ADDENDUM 1

ITB AP 27-20

VPS Parking Lot B Expansion Construction

ADDENDUM NO. 1
to the
PROJECT DOCUMENTS AND SPECIFICATIONS
for
DESTIN-FORT WALTON BEACH AIRPORT
VPS PARKING LOT B EXPANSION
(ITB AP 27-20)

SHEET NUMBER
C-11

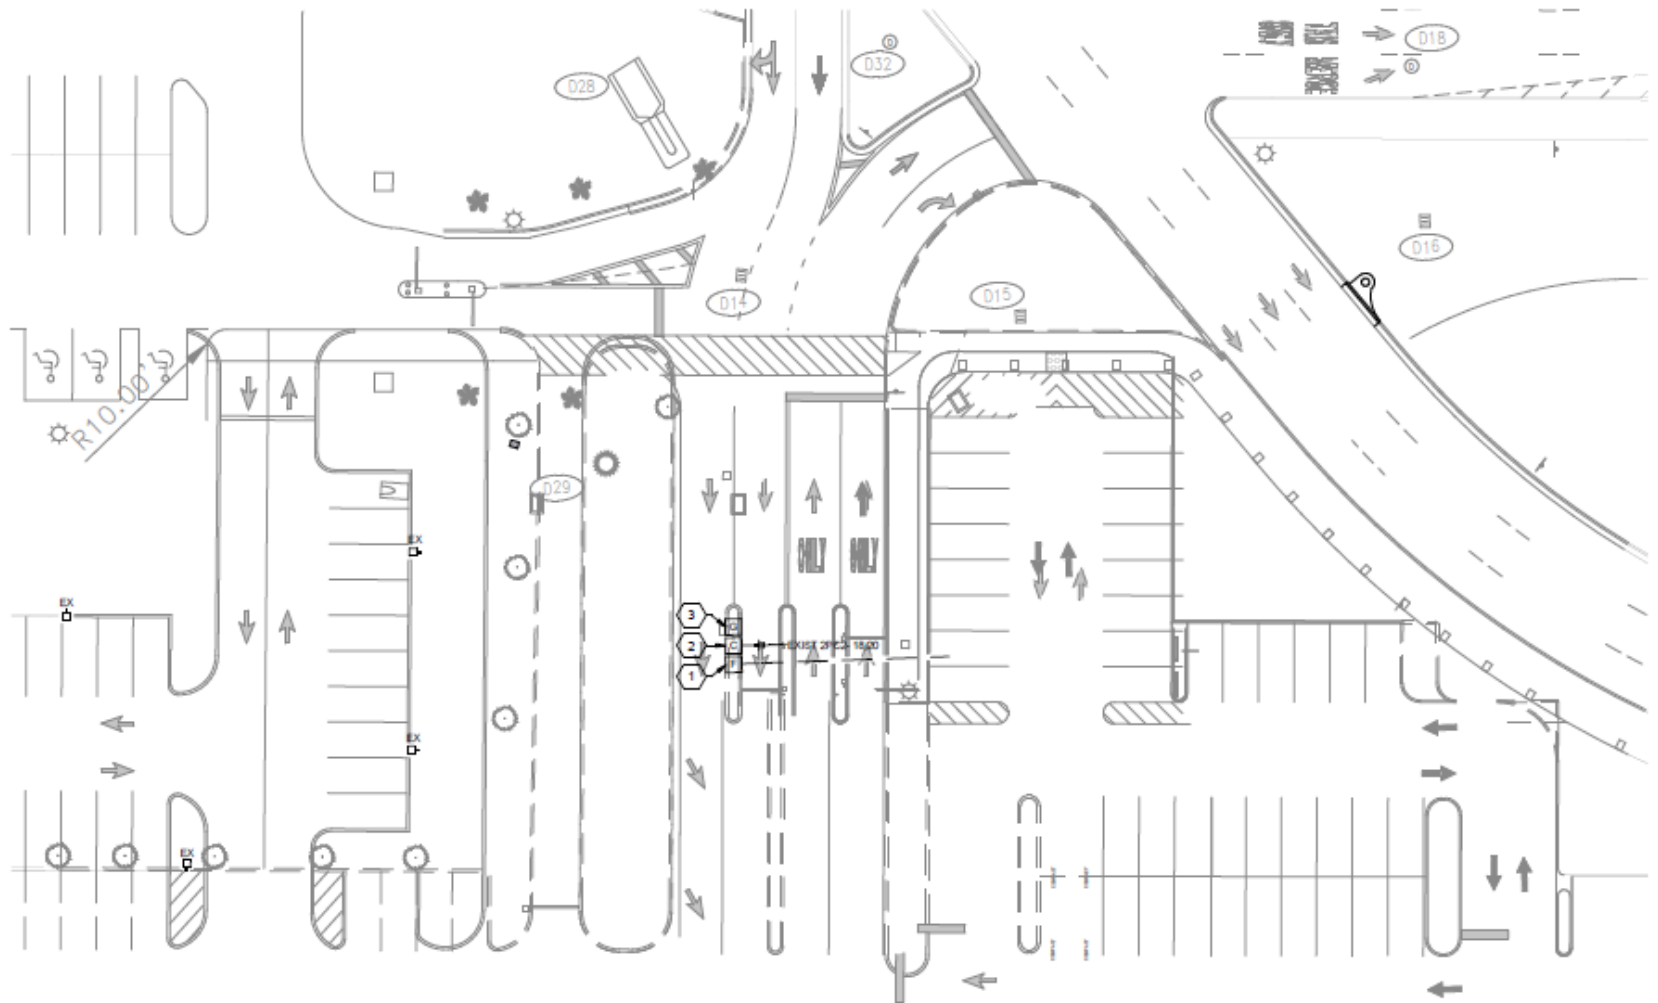
1. Sheet C-11 **REVISE** Fencing Notes, Note 2, as follows:

“Contractor shall trench 12” below grade, and 12” wide (centered on fence line) and backfill with #3 stone along...”
2. Sheet E003 through E108 **REPLACE** Sheets E003 through E108 in their entirety with Sheets E003 through E108 attached as **Attachment C** (9 pages) hereto.
